# HISTORIC AND DESIGN REVIEW COMMISSION

**HDRC CASE NO:** 2022-540  
**ADDRESS:** 315 REFUGIO ST  
**LEGAL DESCRIPTION:** NCB 714 BLK 11 LOT S 67 FT OF 12  
**ZONING:** RM-4, H  
**CITY COUNCIL DIST.:** 1  
**DISTRICT:** Lavaca Historic District  
**APPLICANT:** David Hannan Jr/FISHER HECK ARCHITECTS  
**OWNER:** Robert Knight  
**TYPE OF WORK:** Construction of a 2-story addition  
**APPLICATION RECEIVED:** October 31, 2022  
**60-DAY REVIEW:** Not applicable due to City Council Emergency Orders  
**CASE MANAGER:** Rachel Rettaliata

1. Remove and enclose one of the original front door openings on the primary structure.
2. Modify the fenestration on the primary structure.
3. Construct an approximately 775-square-foot, 2-story rear addition.

1 NEW ADDITION FOOTPRINT  
1/4" = 1'-0"

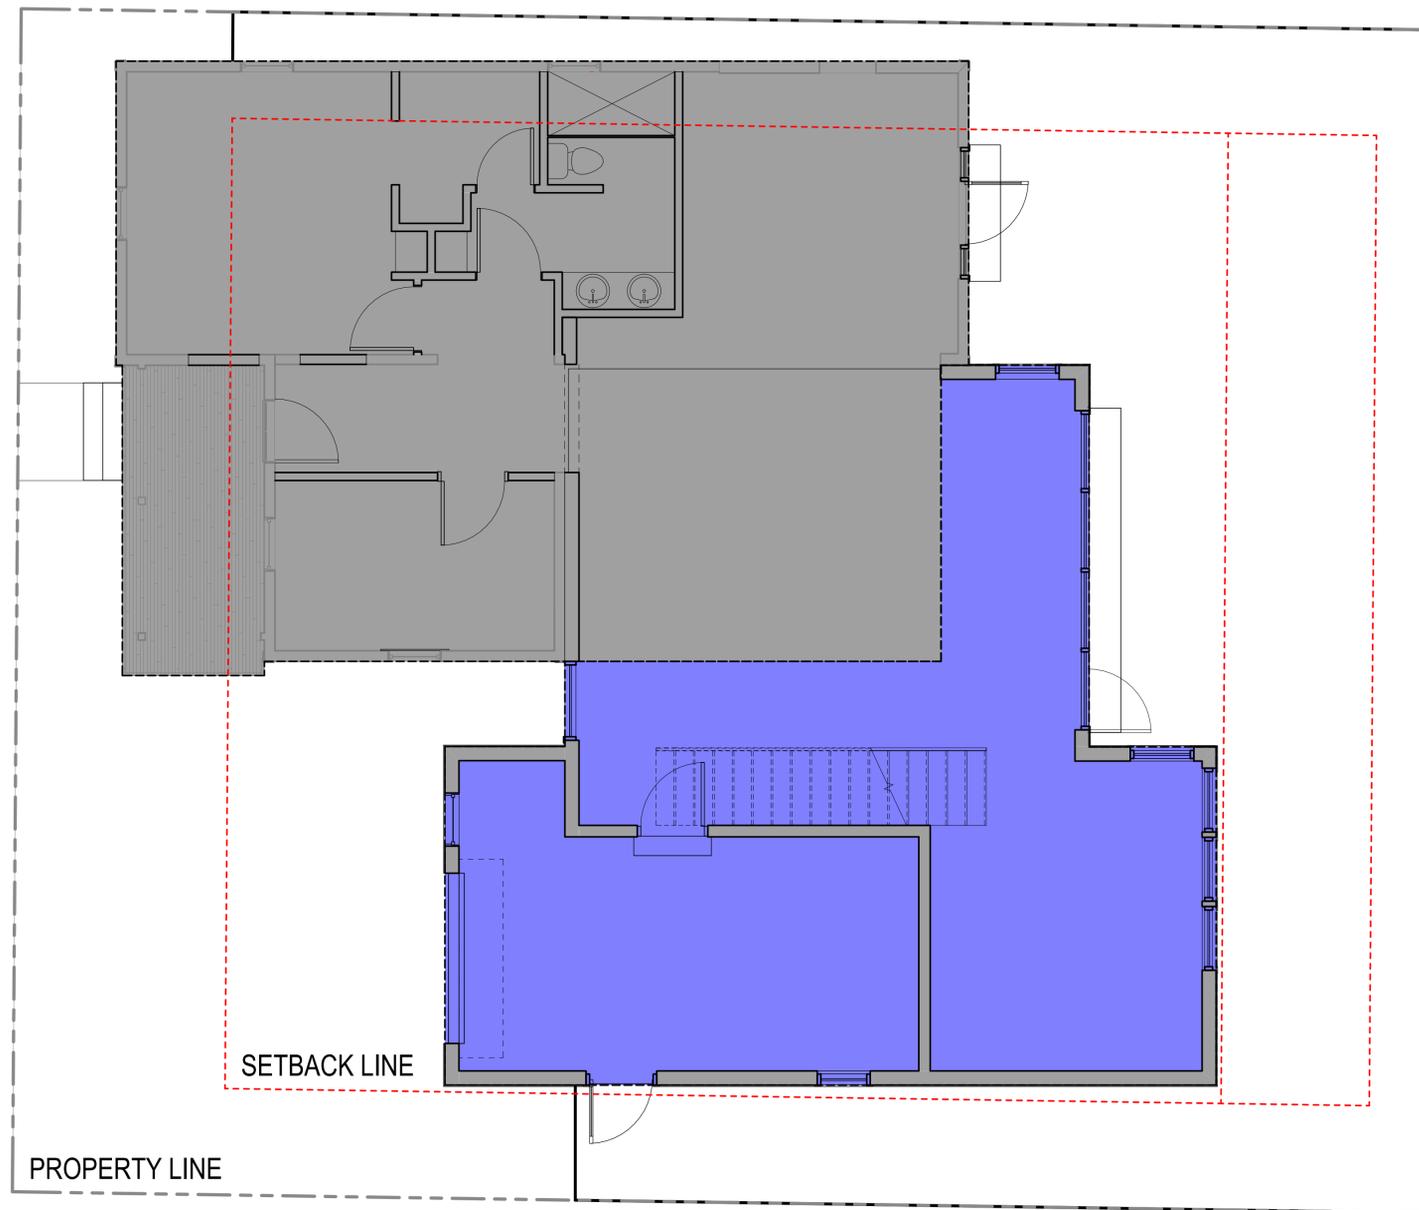
- g. ADDITION: MASSING AND FOOTPRINT – The applicant has proposed to construct an approximately 775-square-foot, 2-story rear addition. The original primary structure is 1,118 square feet. Guideline 1.B.i for Additions stipulates that residential additions should be designed to be subordinate to the principal façade of the original structure in terms of scale and mass. Guideline 2.B.iv for Additions states that the building footprint should respond to the size of the lot. An appropriate yard to building ratio should be maintained for consistency within historic districts. Residential additions should not be so large as to double the existing building footprint, regardless of lot size. While the proposed addition will not double the existing building footprint, the proposed

addition is not subordinate to the principal façade and extends beyond the footprint of the primary structure and will be highly visible from the public right-of-way. Staff finds the proposal inconsistent with the Guidelines.

- ii. That the applicant reduces the overall massing of the rear addition and proposes a rear addition that does not extend beyond the front façade based on finding g. The applicant must submit updated drawings to staff for review prior to returning to the HDRC.

1 PROPOSED LOT COVERAGE PERCENTAGE  
 1/4" = 1'-0"

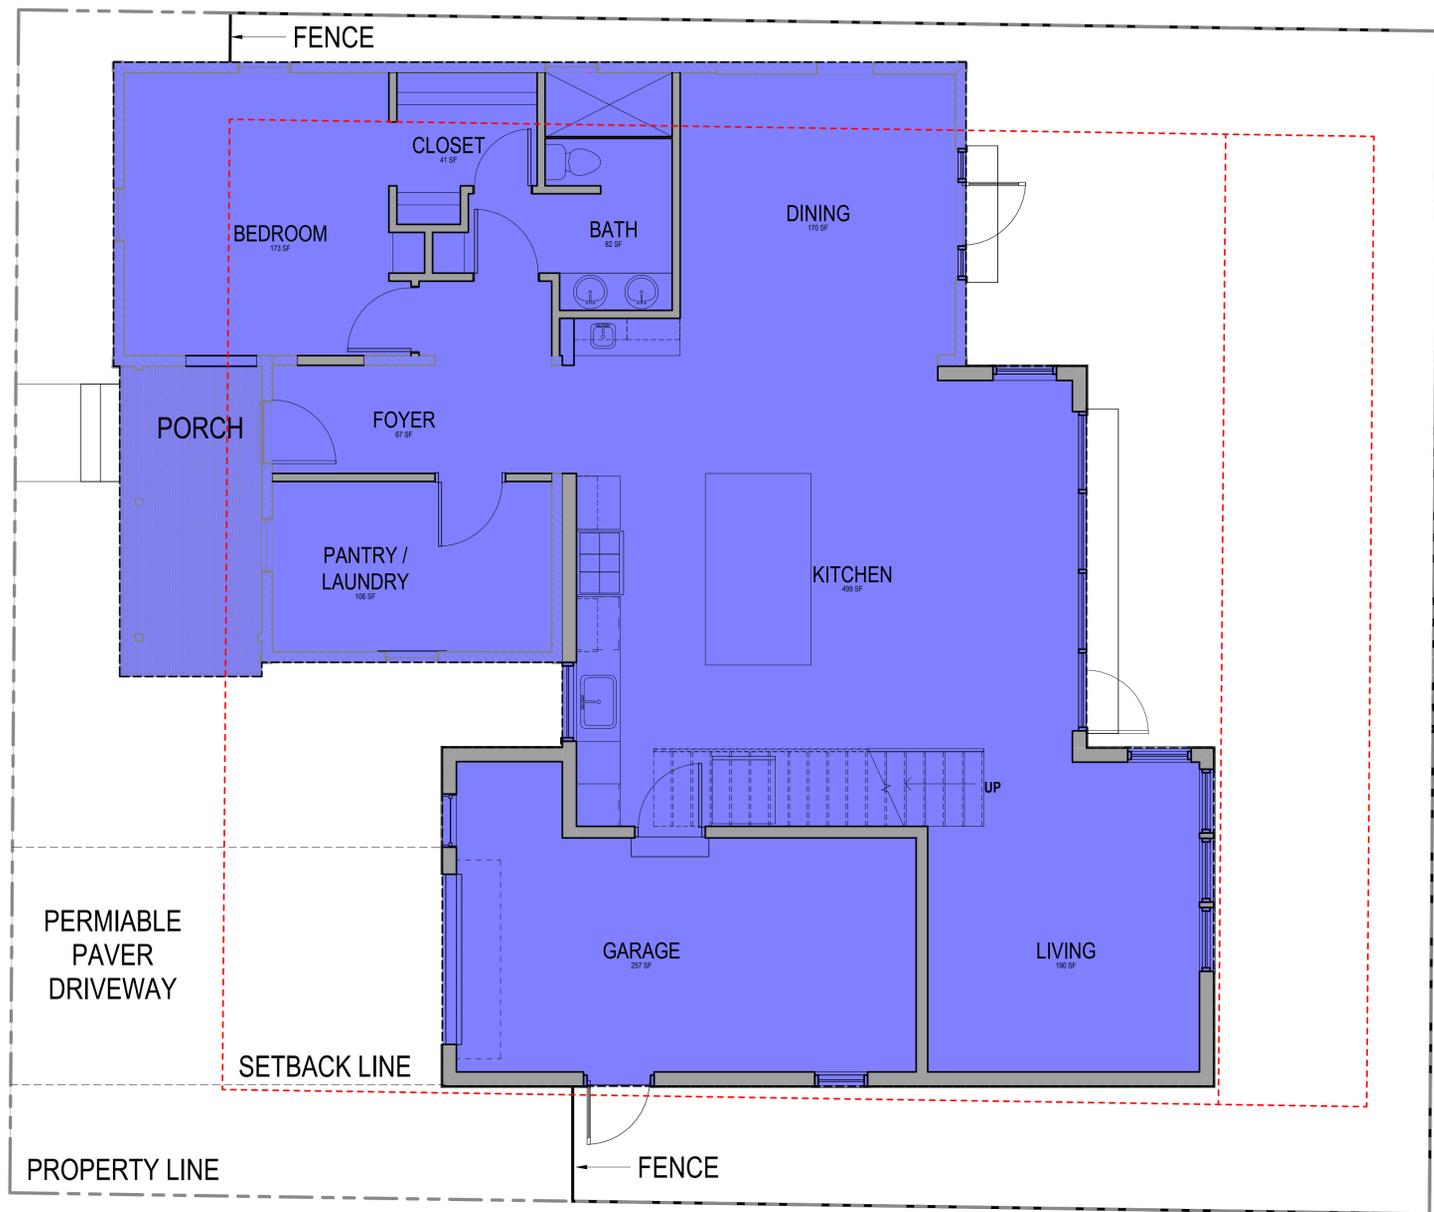
- f. ADDITION: LOT COVERAGE – The applicant has proposed to construct a 2-story rear addition. The total square footage of the primary structure is 1,118 square feet. According to the Historic Design Guidelines, the building footprint for new construction should be limited to no more than 50 percent of the total lot area, unless adjacent historic buildings establish a precedent with a greater building to lot ratio. A building footprint should respond to the size of the lot. The applicant has proposed a total square footage of 1,896 square feet for the primary structure and the proposed addition. The total lot coverage proposed is 50.8% Staff finds the proposal inconsistent with the Guidelines.

- i. That the applicant reduces the total lot coverage to less than 50 percent based on finding f and submits updated plans to staff for review prior to returning to the HDRC for conceptual approval.
